PANEL ASSESSMENT BRIEFING REPORT
SYDNEY WESTERN CITY PLANNING PANEL

PANEL REFERENCE & DA NUMBER	PPSWC-303 - DA-1099/2022
PROPOSAL	<p>Demolition of the existing structures and construction of a mixed-use development comprising 598 apartments, 1289.90sqm of retail space, basement parking accommodating 926 car parking spaces, landscaping and associated structures over 4 Stages.</p> <p>Stage 1: Construction of a 1 x 4-storey and 9 x 8-storey mixed-use development containing 94 apartments.</p> <p>Stage 2: Construction of a 1 x 4-storey and 1 x 8-storey, and 1 x 9-storey development with 164 apartments.</p> <p>Stage 3: Construction of 2 x 8-storey residential flat building containing 148 apartments.</p> <p>Stage 4: 1 x 5-storey, 1 x 8-storey and 1 x 9-storey residential flat building containing 192 apartments.</p> <p>The proposed development is identified as Nominated Integrated Development requiring an approval from the Department of Planning and Environment – Water under the Water Management Act 2000.</p> <p>The proposed development is identified as Integrated Development requiring an approval from the NSW Office of Environment and Heritage under the National Parks and Wildlife Act 19

Figure 3: Site Survey Plan (Source: StrataSurv, Draw No. 4418DT01a2, Rev. A dated 5/05/2020)

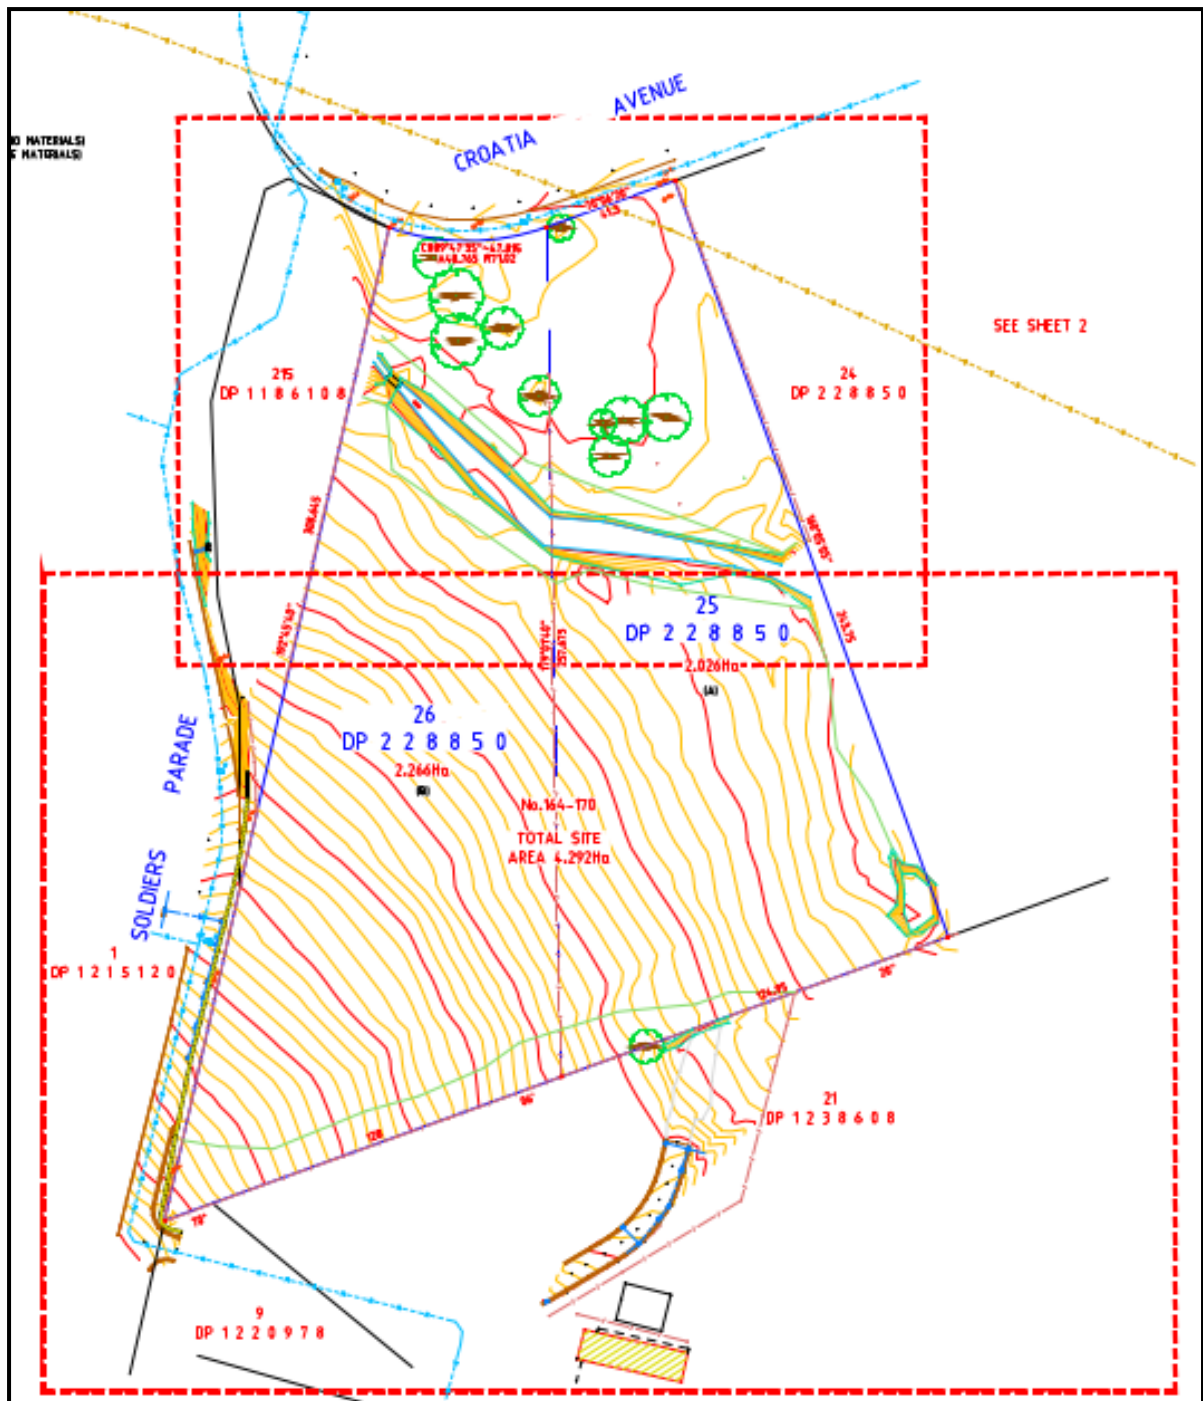
The submitted Survey Plan is inadequate and does not include spot levels, reduced levels (RL), and contour line levels to Australian Height Datum (AHD).
